UTTAR PRADESH METRO RAIL CORPORATION LIMITED

Subject: - Reply to Pre-bid queries and Addendum-01 for tender KNPCC-05

Ref: - Tender KNPCC-5: Design and Construction of Tunnel from start of elevated ramp (after Moti Jheel Metro Station) to end of Nayaganj station including four underground metro stations (viz. Chunniganj, Naveen Market, Bada Chauraha and Nayaganj) and ramp including Architectural finishes, E & M, TVS, ECS etc. on Corridor-1 of Kanpur MRTS Project at Kanpur, Uttar Pradesh.

Reply to Pre-Bid Queries KNPC-05

DRG. NO. **UPMRC/PH-1/KNPCC-05/UTILITY/SHEET - 01** REV. RLT

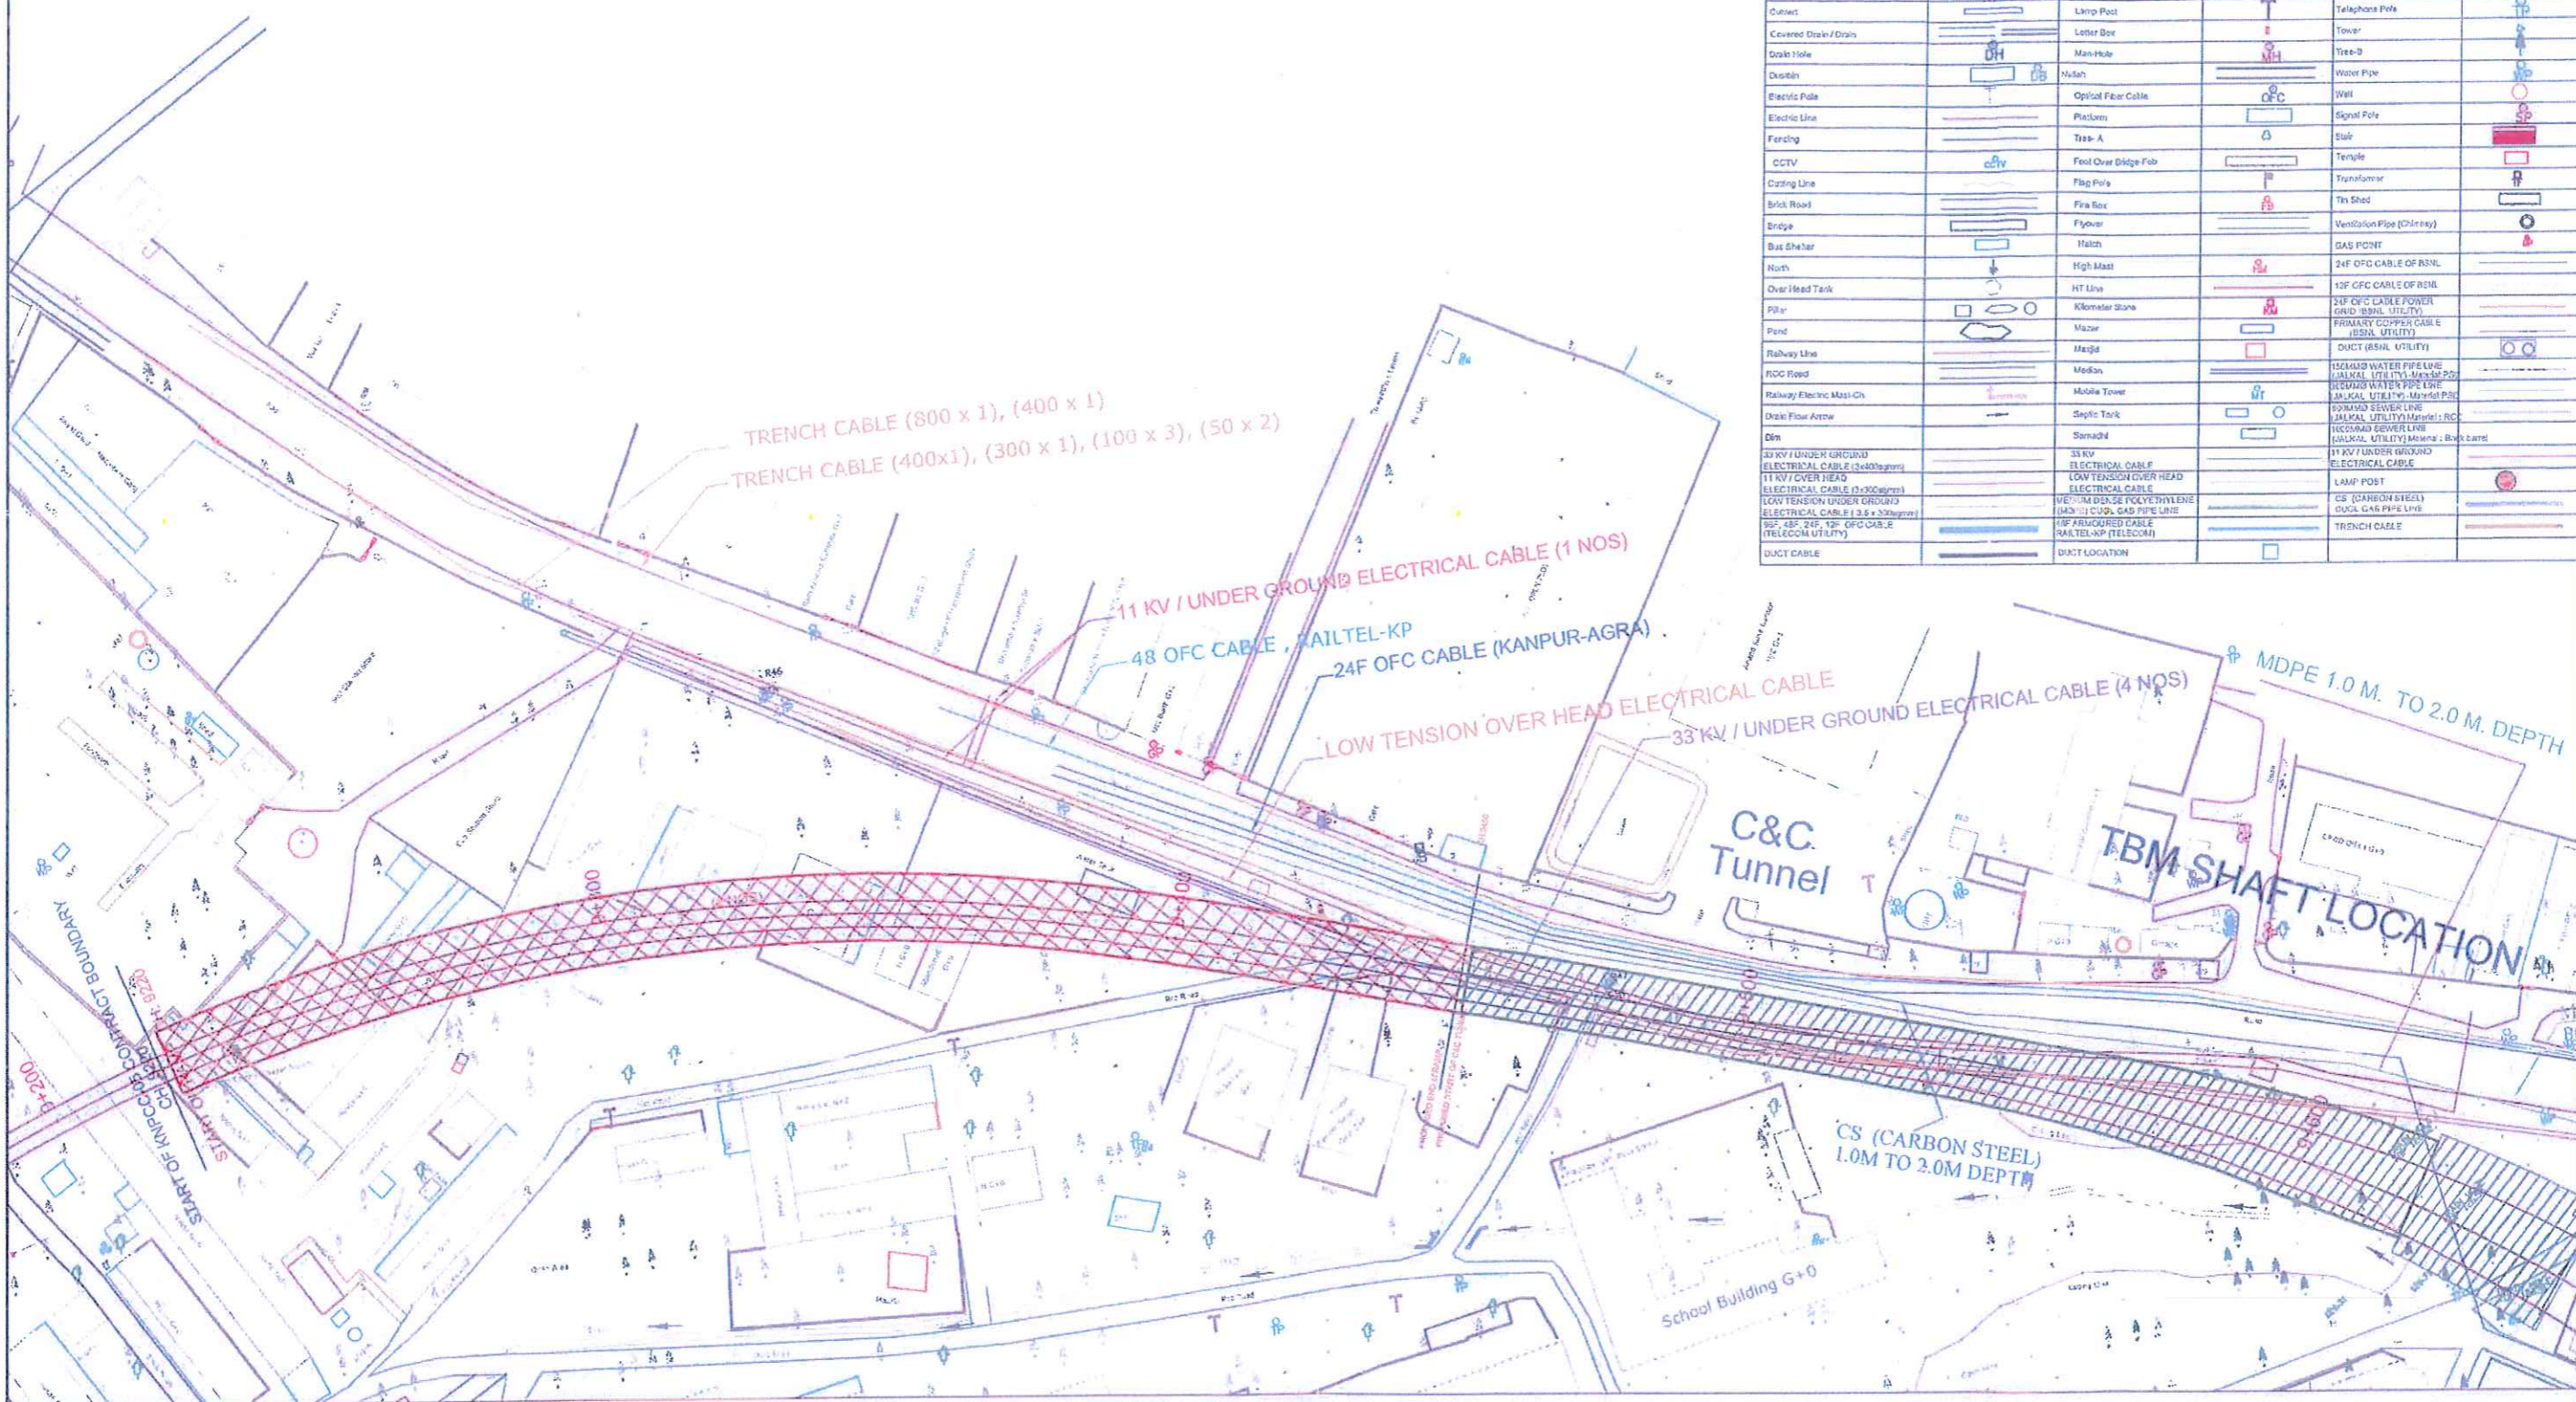
<p>We could not have clarity regarding diameter of sewers, Size of Drains, Capacity of Electric Cables, presence of Gas Lines from the Drawings. These are necessary to work out cost of Utility Diversion</p>	<p>We request you to kindly provide detailed Utility Drawing to enable us plan the Utility supporting, Utility Diversion and work out their costs.</p>	<p>Please refer to clause B-2.3 of ITT and Annexure-01 of (utility drawing No. UPMRCL/CPM-3/KNPCC05/UTILITY R-1) of addendum-1.</p>

UPMRC- DESIGN-UG-ST-115
R1 NTS
STATUS TENDER

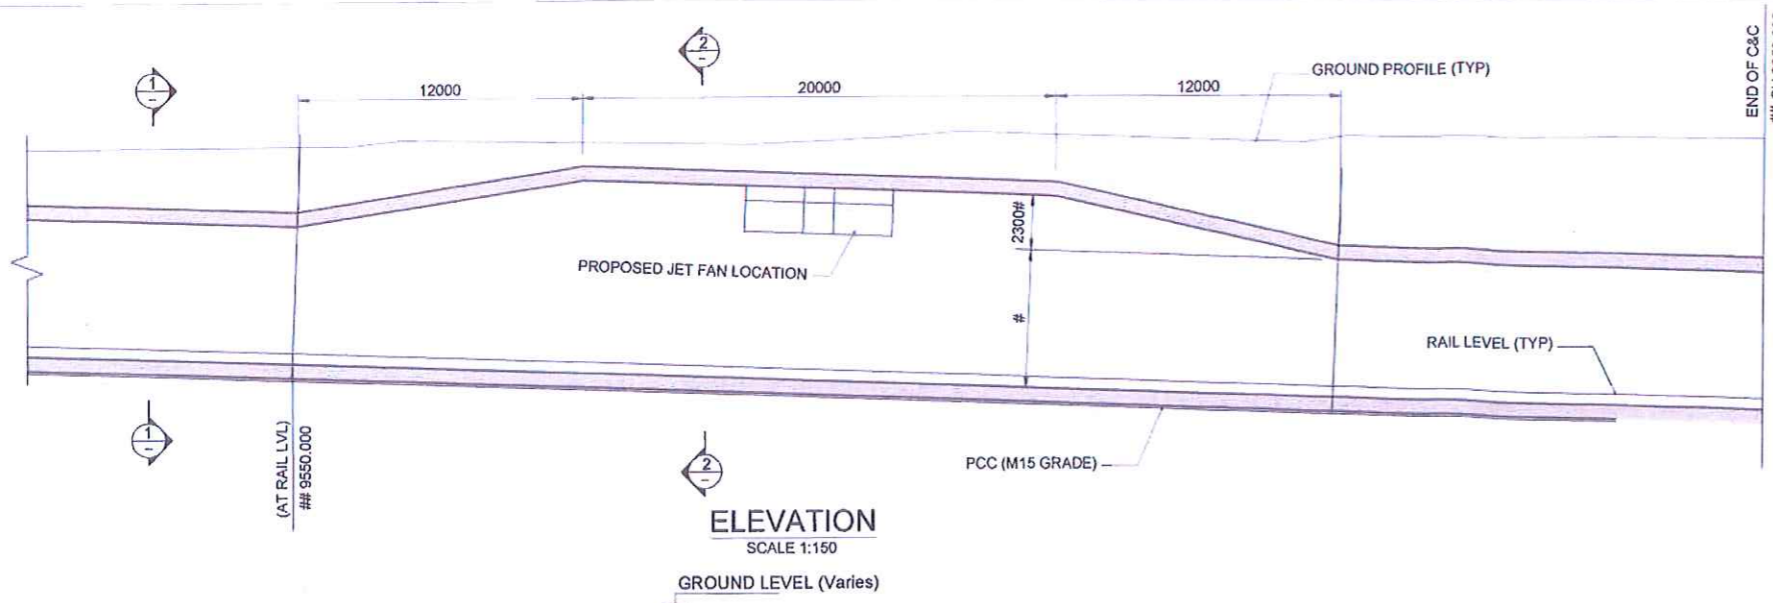
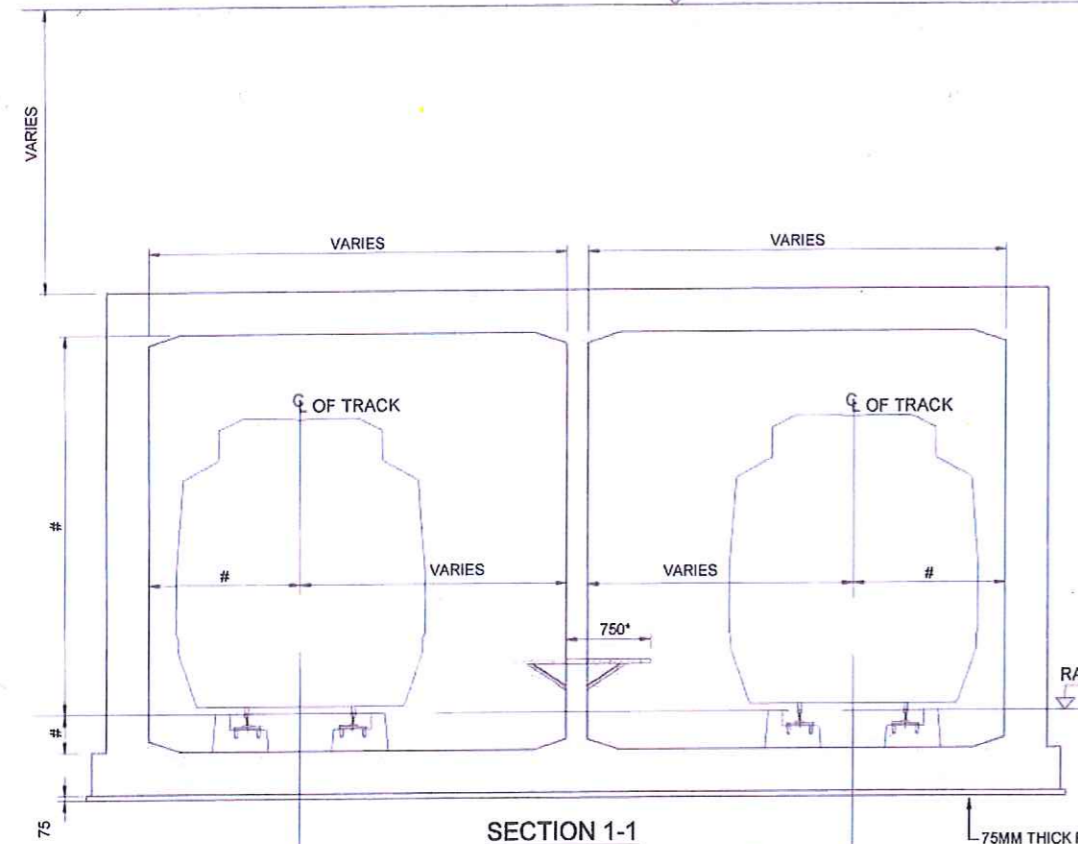
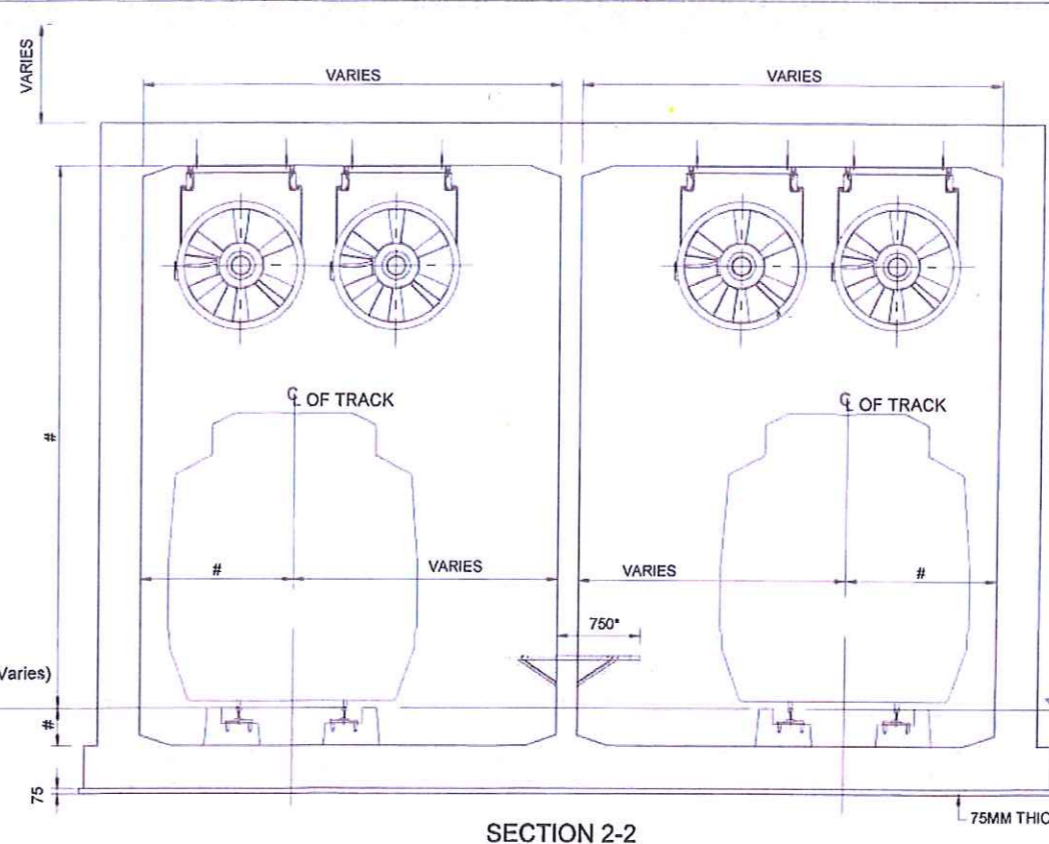
44	UPMRC-DESIGN-JUG-ST-115		Cross section shows the distance between wall and track centre with additional distance as clearance (X)	The SOD details are not available in bid document. Please provide the SOD.	Please refer to SOD attached as annexure-05 of Addendum-1.
45	Vol. 4 clause 2.7.5	49	Ground water table shown in the tender GI shows no presence of ground water. Design requirement is for last 20 years data +4m, while for uplift at ground level.	Uplift is checked for ground water table at ground level, however water level doesnot found 30 m below ground as per tender geotechnical reports. While the structures are designed for lower water pressure of maximum ground water from last 20 years +4m. The design shall comply for uplift and structural design for same water table. Please consider.	As per tender conditions.
46	Vol. No 4 Clause 2.7.8	55	Passenger emergency evacuation design for cross passages running tunnels which are constructed by either cut and cover or bored method shall be in accordance with the requirements of NFPA 130	Generally cross passages for most of Indian metro projects followed based on NBC-2016. Please confirm.	Cross passage location shall be proposed by contractor based on Latest NBC guidelines and drainage requirement.
